Re: Buffalo River Hydroelectric Project, FERC Project #1413

Construction Plans

The licensee has received comments from USFS, IDFG, USFWS and HFF as of May 9, 2005, a copy of the comment letters are enclosed as Exhibit A.

Figure A-1

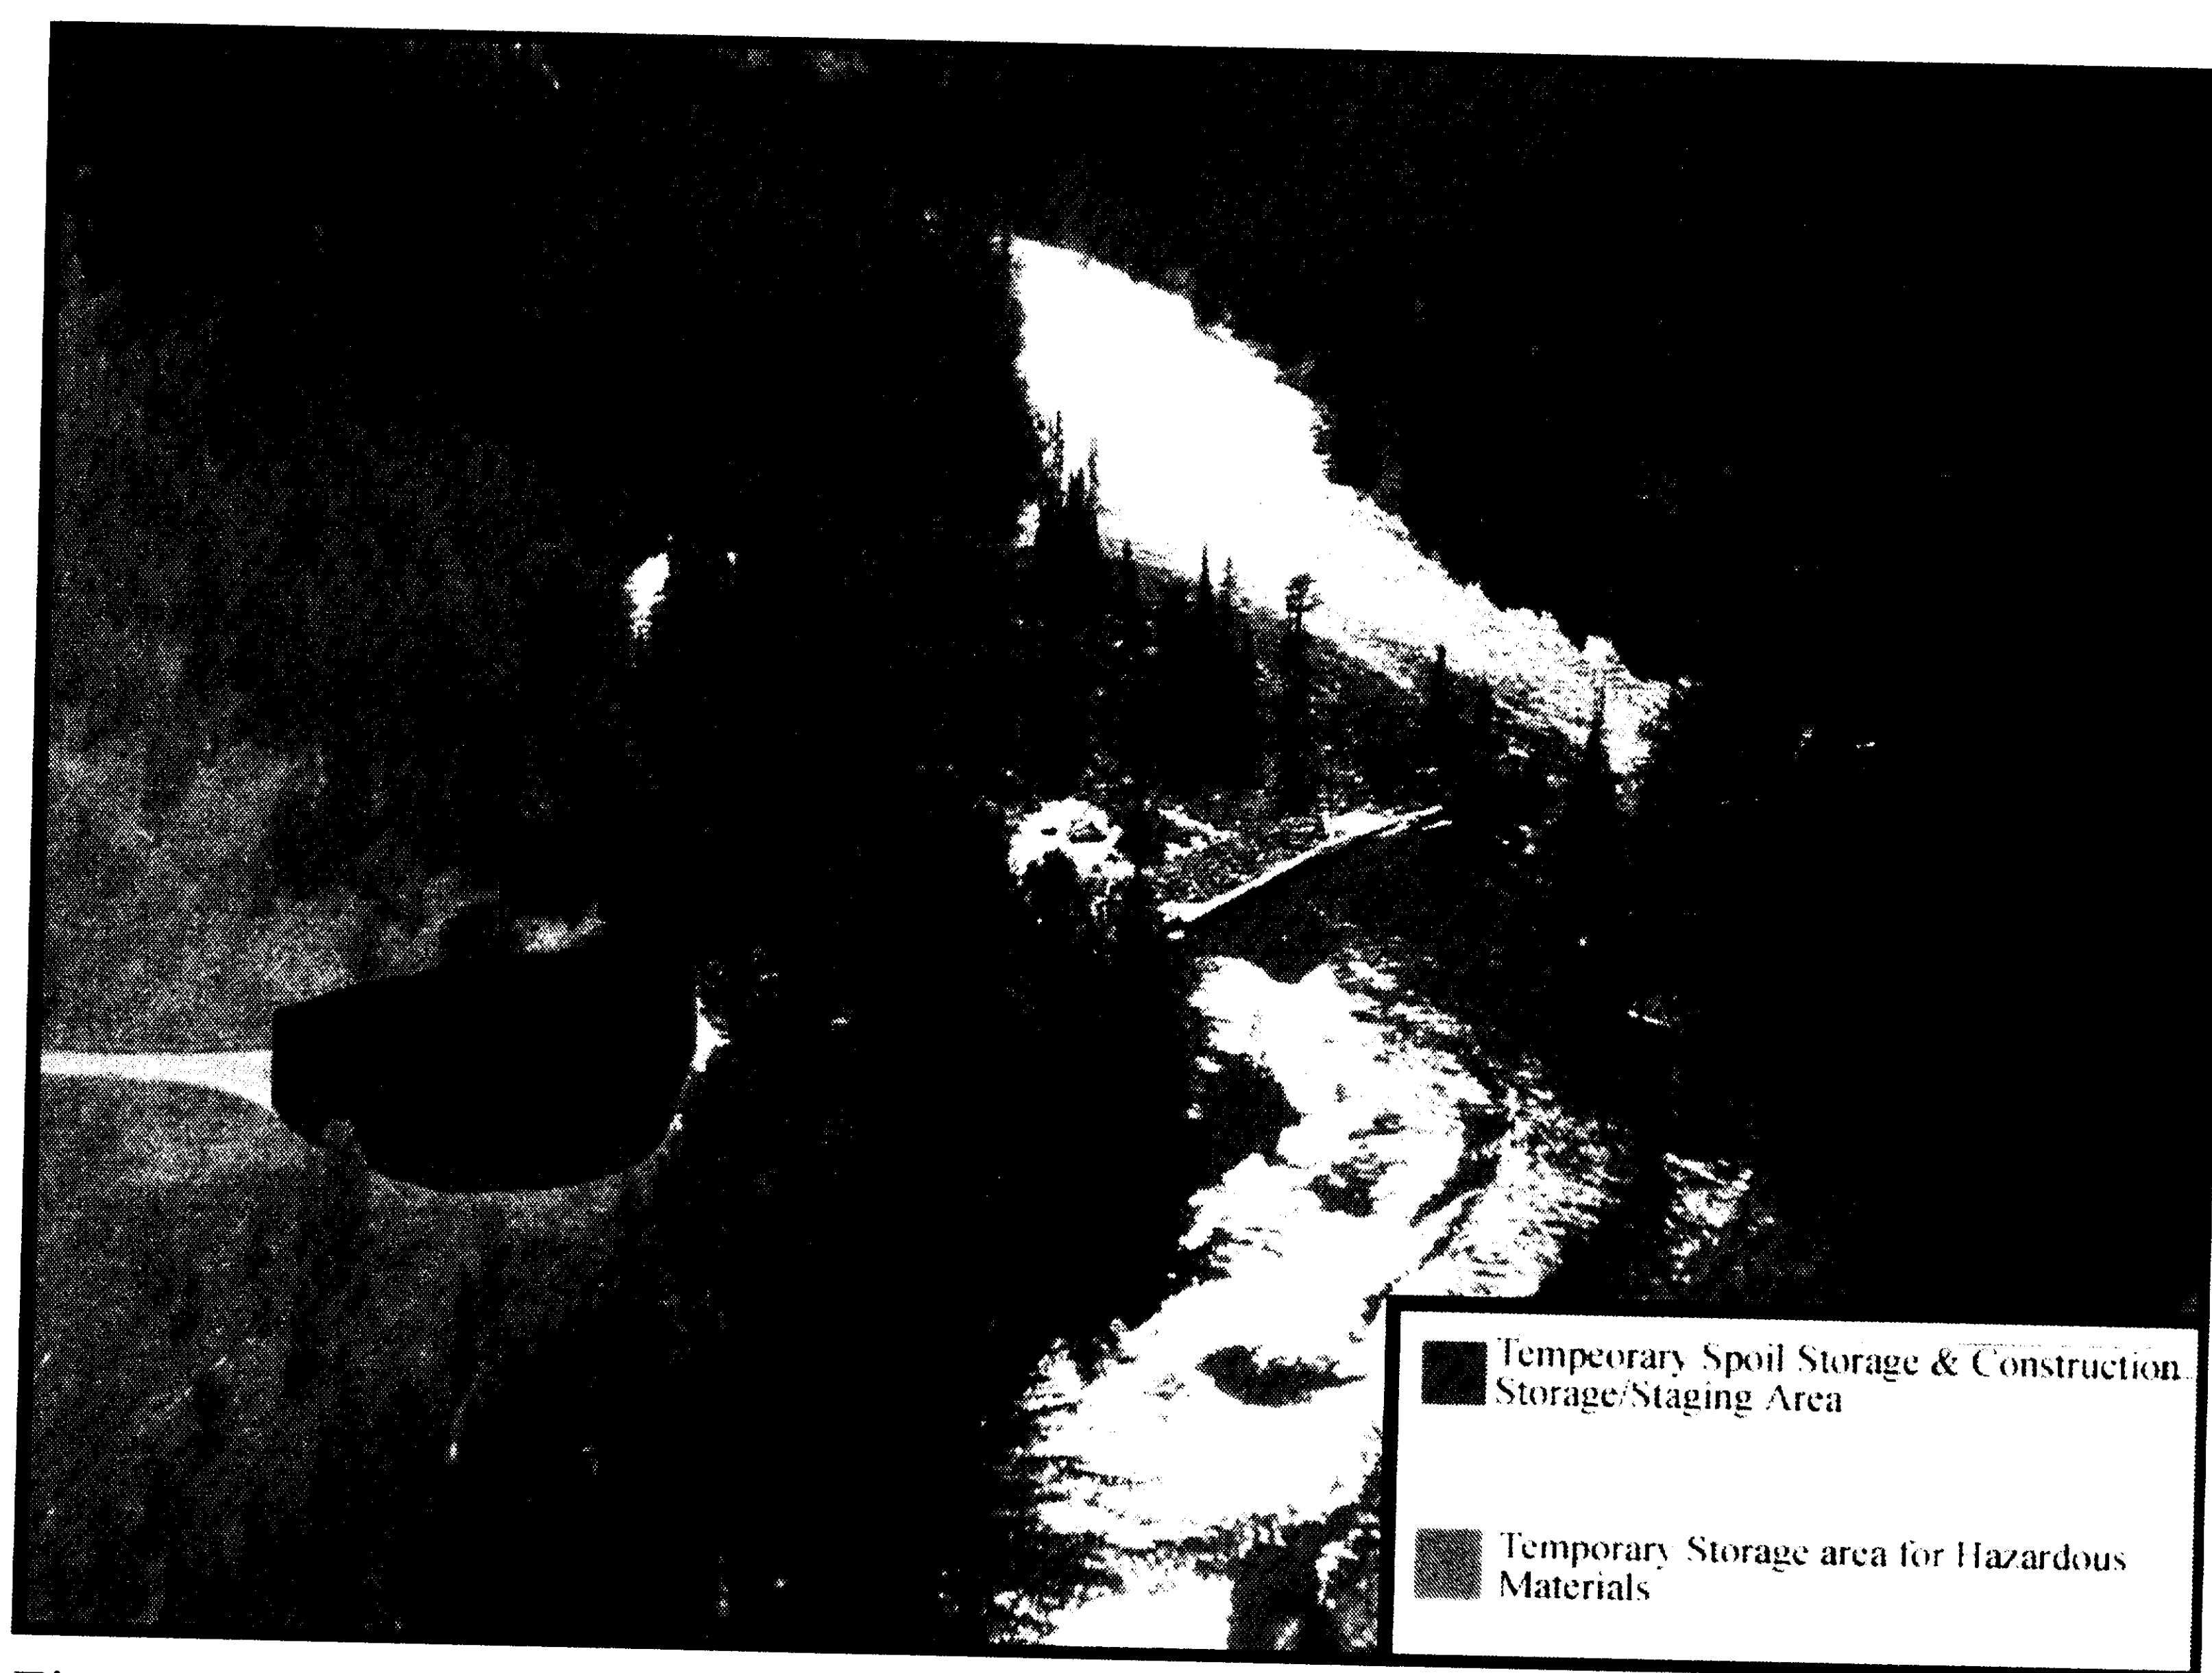
3.1 - 1 The Forest requests that the staging area be moved to an approved location southwest of the proposed staging site. The staging area needs specific locations to be identified for spoil storage, a hazardous materials storage area and a concrete cleaning area to avoid unnecessary site impacts. The plan needs to state specifically that the area outside of the staging area will not be used. The edge of the spoil piles needs to be at least 50 feet away from the slope break near the edge of the trees not 50 feet from the river. The hazardous materials need to be located at least 150 feet from the river. A suggestion would be to place it in the southeast corner of the staging area. The staging area needs to have a silt fence or equivalent between it and the river. Restoration of the staging area needs detailing in the Revegetation Plan.

**Response:** The applicant has moved the temporary storage area for hazardous materials and concrete cleaning to the southeast corner of the stage area as seen in Figure A-1.

Figure A-3

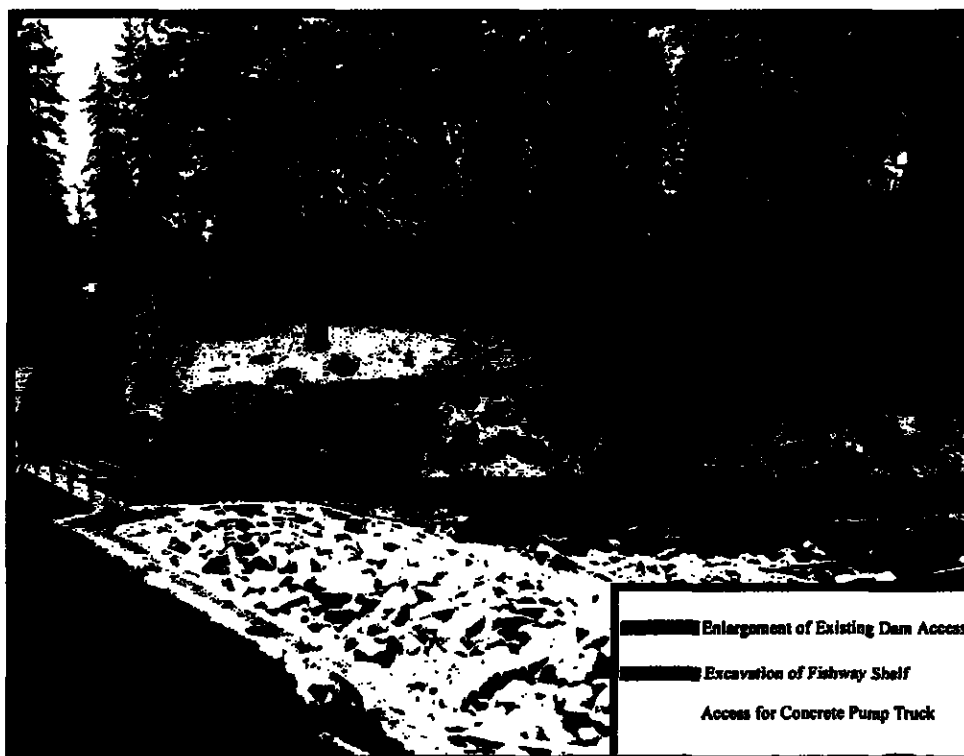
3.1 -5 The Forest requests that decomposable fiber mats are replaced by hydro mulch as hydro mulch is less susceptible to impacts by animals that sometimes get entangled in fiber mats. If straw or straw bales are used they shall be certified weed free. Figure A-3 shows an access road in red to the dam with no explanation of surfacing or how it will be made passable nor does the Vegetation Management Plan provide details concerning its restoration. No detail is given on the concrete truck access, the more native soil that can be left in place the easier site restoration will be.

**Response:** Hydro mulch will be substituted for fiber mats where necessary and all straw or straw bales used will be certified weed free. Vegetation and large substrate will be removed to create a temporary access road (Figure A-3). Because surfacing material that could aid in equipment access would hinder revegetation efforts, none have been proposed at this time.

Figure D-1a

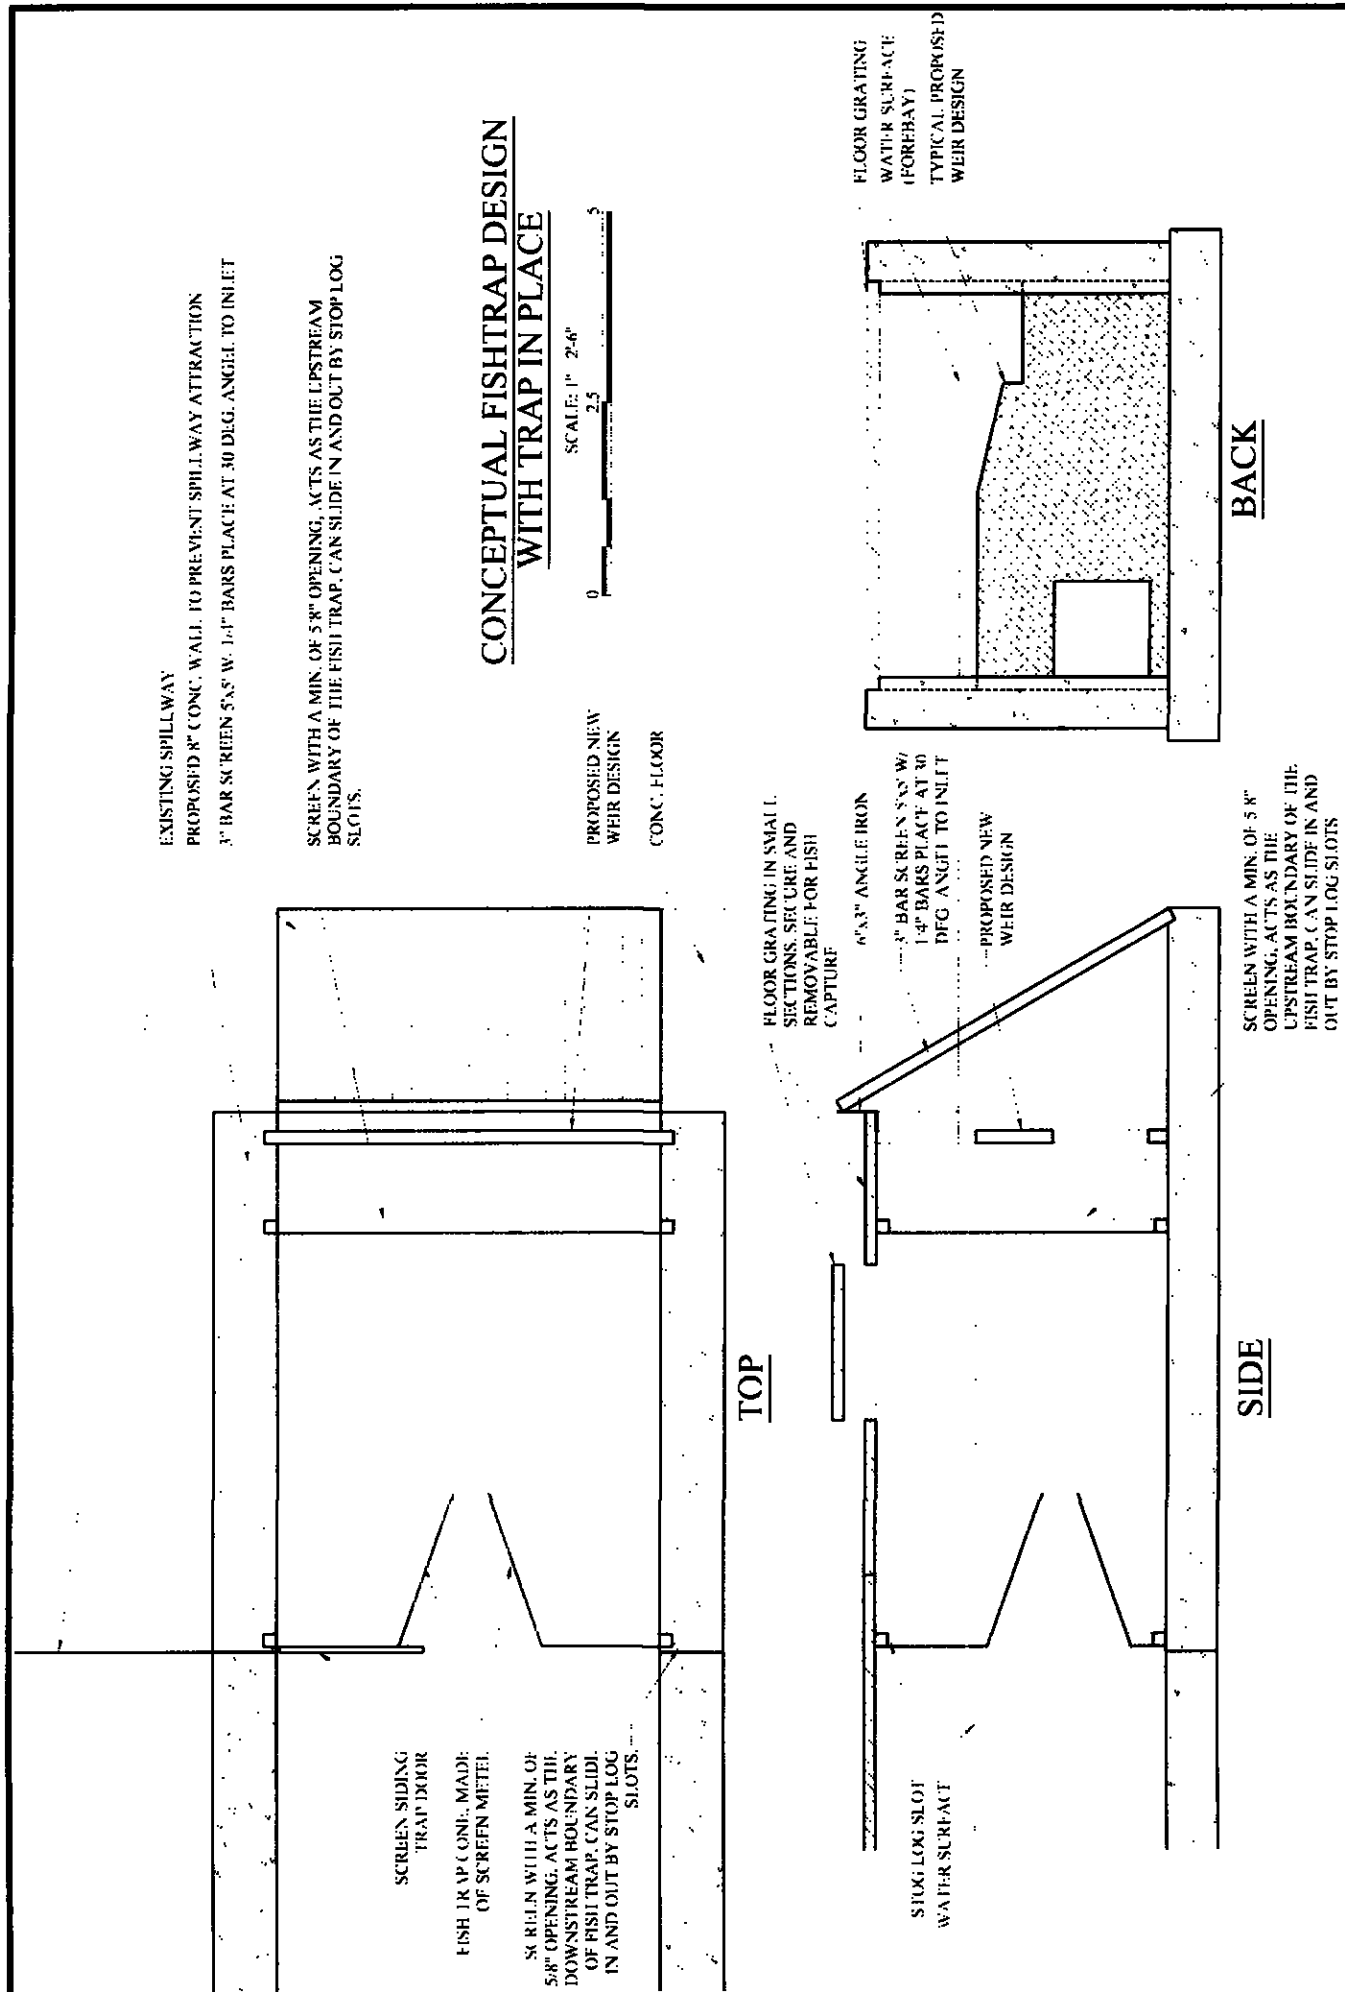
Section 2.2 Fish Ladder Monitoring - Please provide a diagram or engineering drawing of the fish trap to be used in monitoring upstream fish used of the fishway. We recognize that the drawing may be conceptual at this point. We request that the monitoring project be designed to verify that downstream fish passage through the fishway occurs as well as upstream fish passage. We recognize the majority of flow, and presumably fish, will wash downstream via the overflow.

- have a screen or vertical opening of no greater than 5/8"
- be 3-5 feet wide and at least 5 feet long to provide refuge from intake
- be secured to prevent tampering with access provided to IDFG, HFF, and USFS,
- designed to allow processing in the dry
- have a secured opening where fish can pass quickly through when not being captured
- be designed so as to prevent fall back into the fish ladder of trapped fish
- be designed to allow crowding of the fish to ensure efficient capture for processing
- be removable
- designed so flows to the ladder can be shut off for maintenance or inspection

**Response:** Please see Figure D-1, end of the section, for a conceptual diagram of the fish trap that will be located on the upstream end of the fishway. The applicant will continue to work with the IDFG, USFS, and the HFF in refining the appropriate fish collection device's to monitor fish passage.

**Response:** Please see Figure D-1, end of the section, for a conceptual diagram of the fish trap that will be located on the upstream end of the fishway. The applicant will continue to work with the IDFG, USFS, and the HFF in refining the appropriate fish collection device's to monitor fish passage.
